**ALERT SERVICE BULLETIN**  
REVISION NOTICE  
**Bell Helicopter** **TEXTRON**  
A Subsidiary of Textron Inc.

SUBJECT: **REVISION "D" TO ALERT SERVICE BULLETIN 205B-00-34 (TAIL ROTOR BLADE 212-010-750-009 THROUGH -129 TIP BLOCK MODIFICATION)**

NO. 205B-00-34

**SUBJECT:** TAIL ROTOR BLADE P/N 212-010-750-009  
THROUGH -129, TIP BLOCK RETENTION  
MODIFICATION

**Figure 1**  
**212-010-750-ALL**  
**TAIL ROTOR TIP RETENTION MOD**

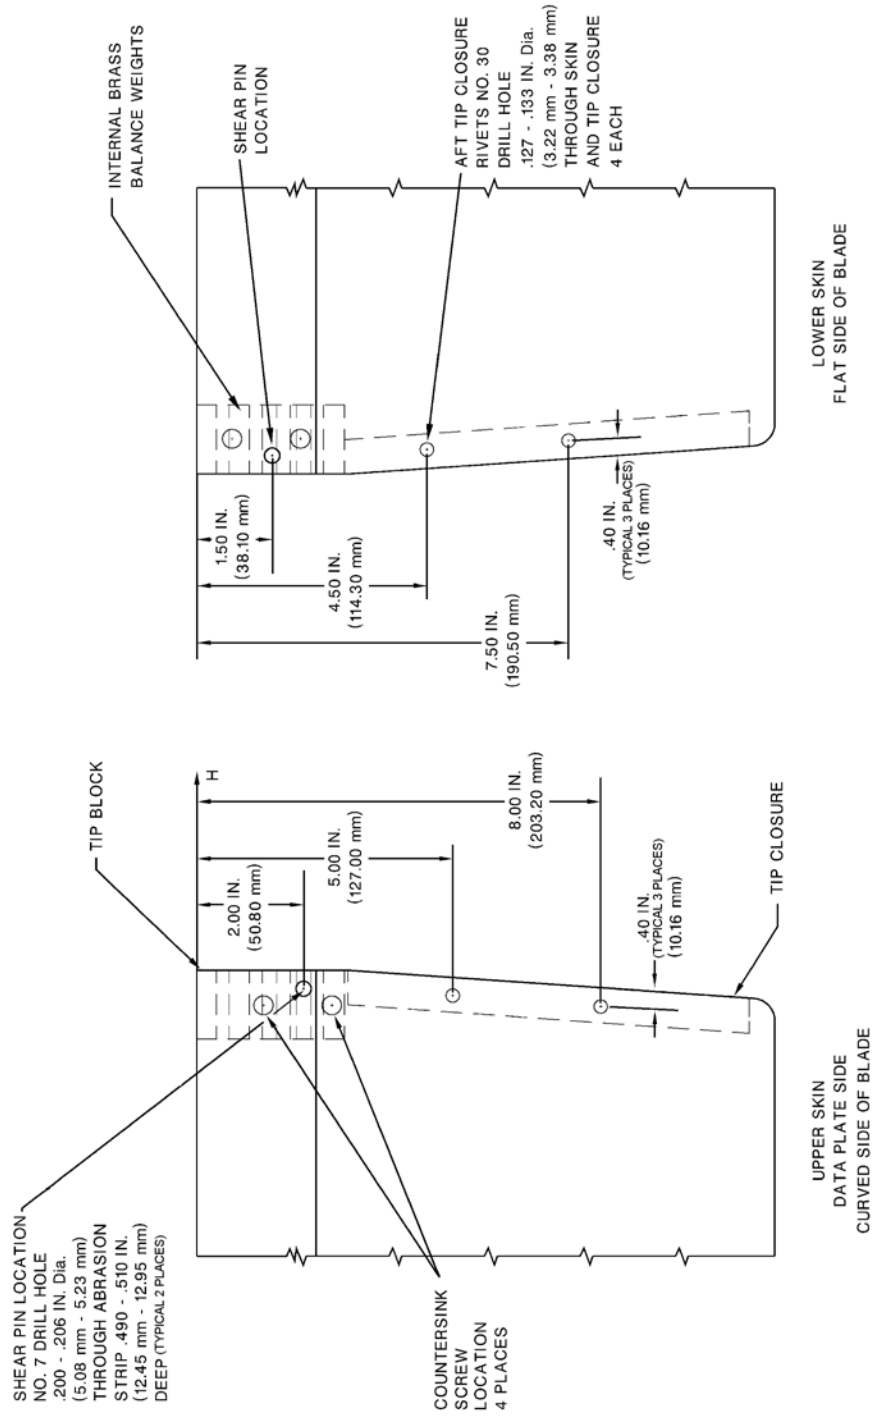
**Revision "D"** to this bulletin provides an alternate fastener for the tail rotor blade tip closure rivets installation.

This alternate rivet P/N NAS9307M-4-01 has a monel sleeve which is more erosion-resistant. Installation of this rivet with sealant MIL-PRF-81733 in lieu of adhesive 299-947-100 TY2 CL 2 will offer a better protection against water contamination and corrosion. An oversize rivet P/N NAS9310M-4-01 is also added to the material list.

1. Deleted
2. Inspect forward tip weight retention block and aft tip closure for voids. Remove any blade from service that exhibits voids in excess of CR&O limitations.
3. Inspect forward tip block attachment countersink screws. 4 locations. See Figure 1. Inspect to insure that the head of the countersunk screw is flush with the surface of the abrasion strip.
4. T/R blades that have the screws flush with the surface of the abrasion strip in all 4 locations do not require shear pin installation. T/R blades with one or more of the screws that are set below the surface of the abrasion strip or are covered with filler material may not provide acceptable retention of the tip block in the event of adhesive failure and will require shear pin installation. The limit is flush to 0.010 inch (0.0254 mm) high.
5. The aft tip closure rivet installation must be accomplished on all tail rotor blades.

1. Using a clean, sharp No. 7 drill bit, drill a **.50** inch deep shear pin installation hole as shown on Figure 1. The upper surface of the blade can be identified as the curved side of the blade and is same side as the data plate. Likewise the lower surface of the blade is the most flat side of the blade. The shear pin installation holes are located at 2.0 inches (projected) aft of the leading edge on the upper surface and 1.5 inches (projected) aft of the leading edge on the lower surface.

1. Using a clean, sharp no.30 drill bit, drill two rivet installation holes on both the upper and lower surface of the blade tip as shown in Figure 1. It is not necessary to remove the paint in the area.

2. De-burr drilled holes and verify rivet fit. Clean M7885/2-4-01 or NAS 9307M-4-01 rivets and drilled holes with Aliphatic Naphtha. Wipe dry before solvent evaporates.

3. Obtain a kit of sealant per MIL-PRF-81733. Thoroughly mix the accelerator, add it to the base product, then thoroughly mix the mixture until a uniform color, devoid of streaks, is achieved.

4. Coat rivet-shanks with MIL-PRF-81733 sealant and install verifying that rivet heads are seated firmly with blade skin. Allow a fillet of adhesive to squeeze out around rivet heads to insure blade is sealed.

5. Allow sealant to cure for 24 hours at room temperature. Refinish rivet heads in accordance with 212 MM for blade refinishing. Re-identify the modified blade by the addition of "FM" after the part number (i.e., 212-010-750-109FM).
